CITY OF ALBUQUERQUE

November 2, 2021

Re: Dallas Commercial
1500 1st St. NW
Traffic Circulation Layout
Engineer's Stamp 10-18-21 (J14-D196)

Based upon the information provided in your submittal received 11-01-21, the above referenced plan cannot be approved for Building Permit until the following comments are addressed:

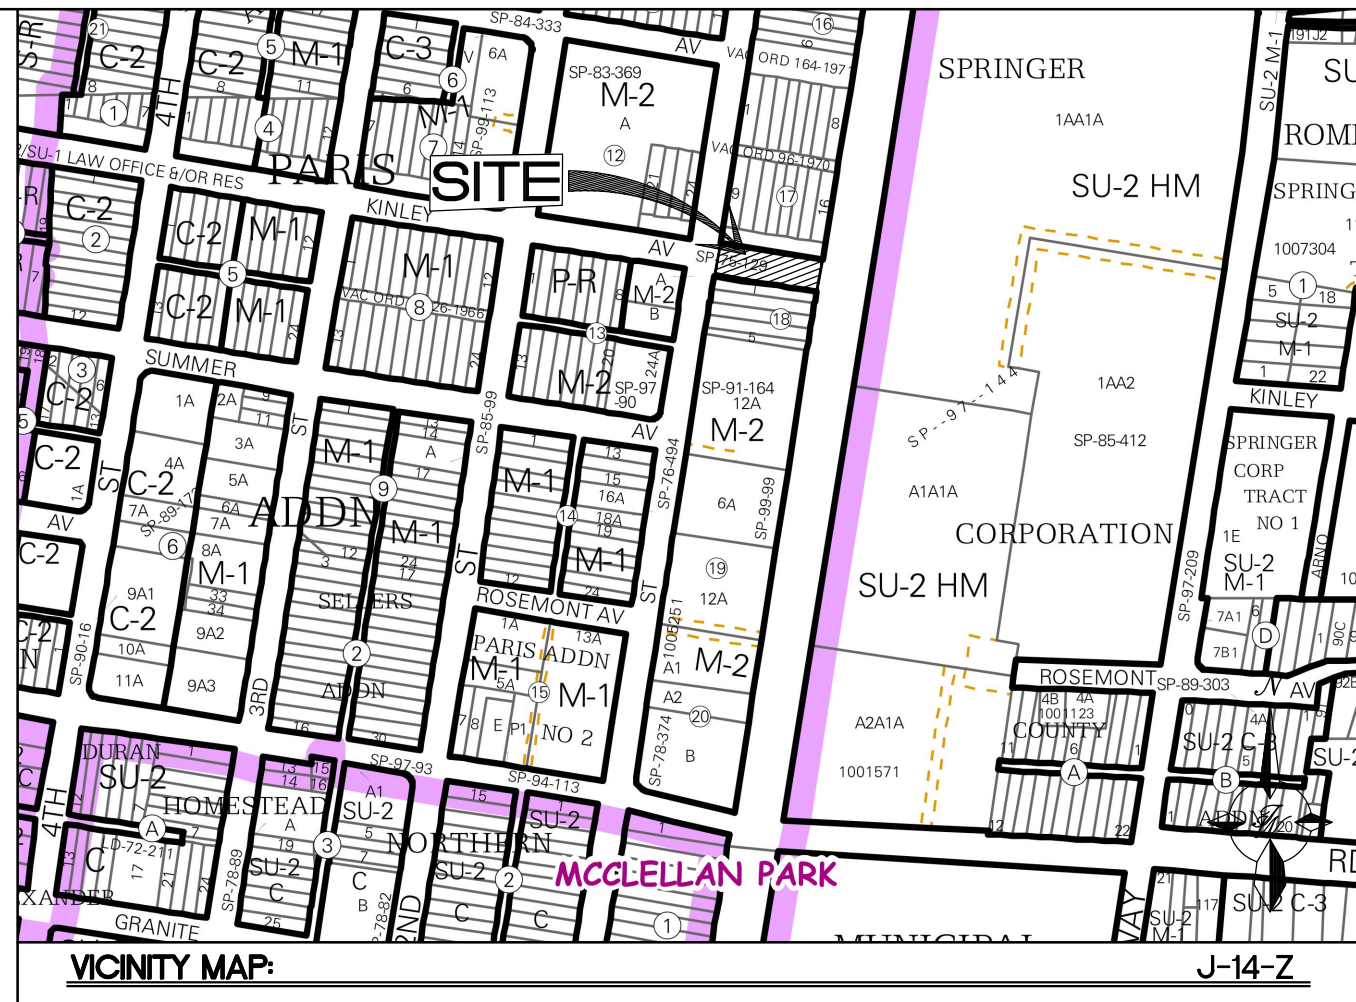
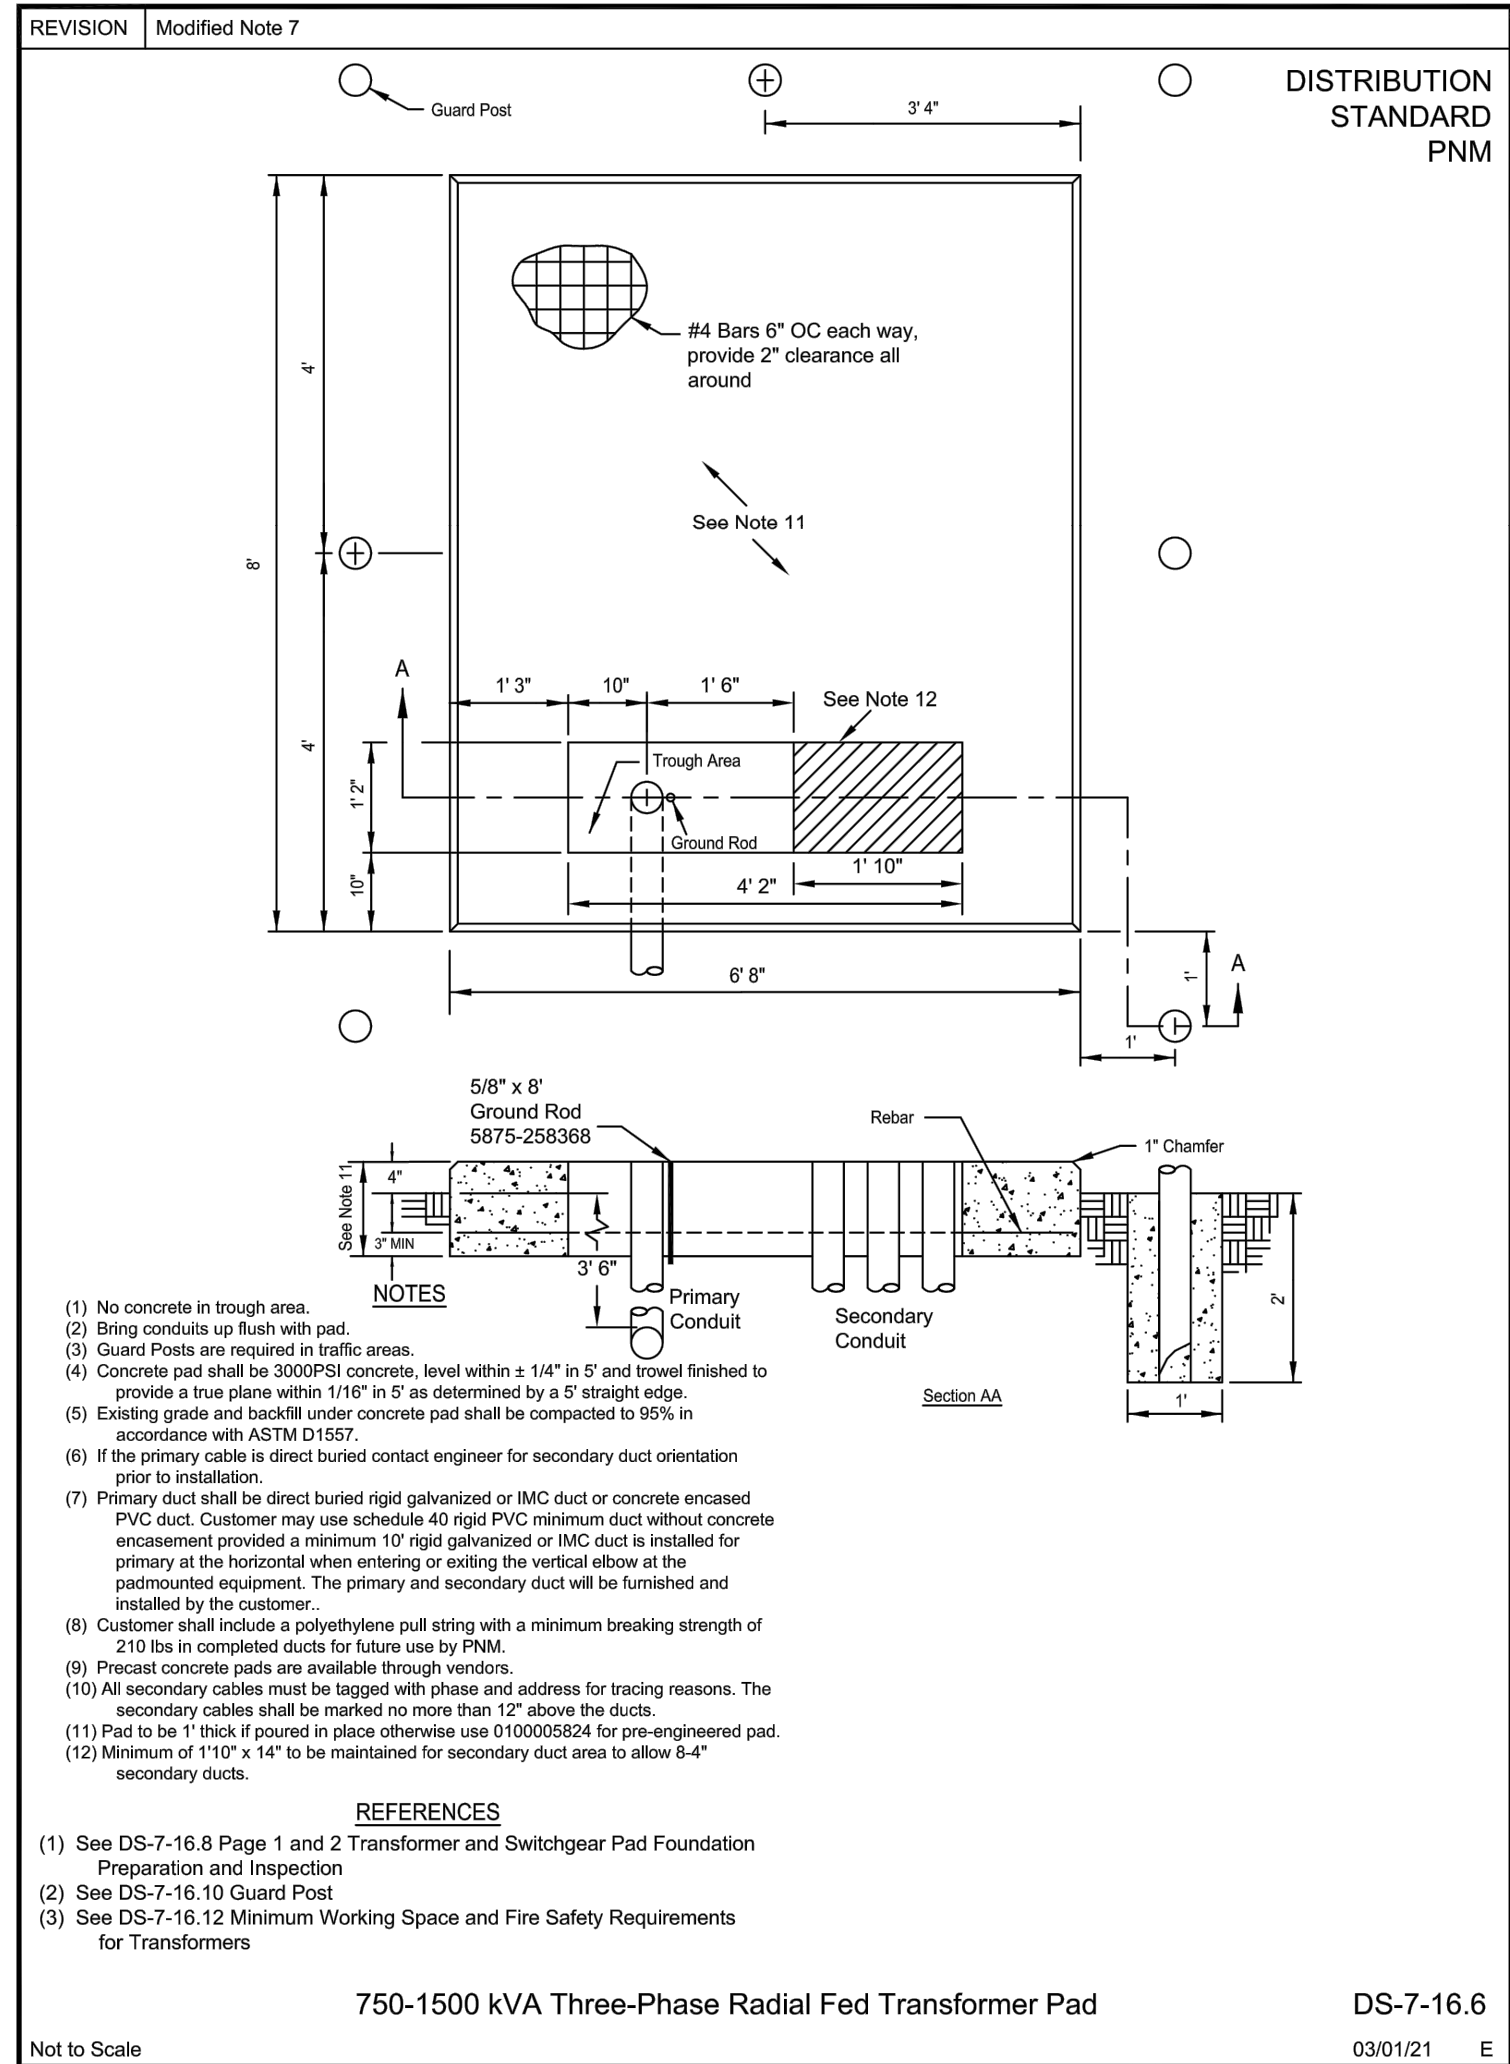
1. Please identify all existing buildings, doors, structures, sidewalks, curbs, drive pads, wall and anything that influences the parking and circulation on the site.

2. Identify all existing access easements.
3. Sidewalk along street (Kinley Ave.) should be placed at the property line.
4. An ADA ramp will be required at the corner of 1st St. and Kinley Ave. Reference COA standard DWG.

5. Drive Pad off 1st St. must be updated to current COA standard.
6. It appears there are parking spaces located within public ROW, please provide an existing agreement between landowner and COA agency, Or exclusive easement for this condition

7. Provide dimensions for ADA parking spaces, ADA aisle space, and all parking spaces.
8. Per DPM, a 6 ft. wide ADA accessible pedestrian pathway is required from the ADA parking stall access aisles to the building entrances. Please clearly show this pathway and provide details.

9. Do you have any existing agreement between NMDOT and landowner for existing fence fronting the end of Kinley Avenue and gate access onto RR?
10. Revocable Permit is required for all proposed and existing equipment located within public ROW, such as wall, signs, and etc. **See attachment for Revocable Permit. This includes air space.**

11. A sidewalk and curb and gutter need to be built per city standards on Kinley Ave. Please contact Jeanne Wolfenbarger for variance.
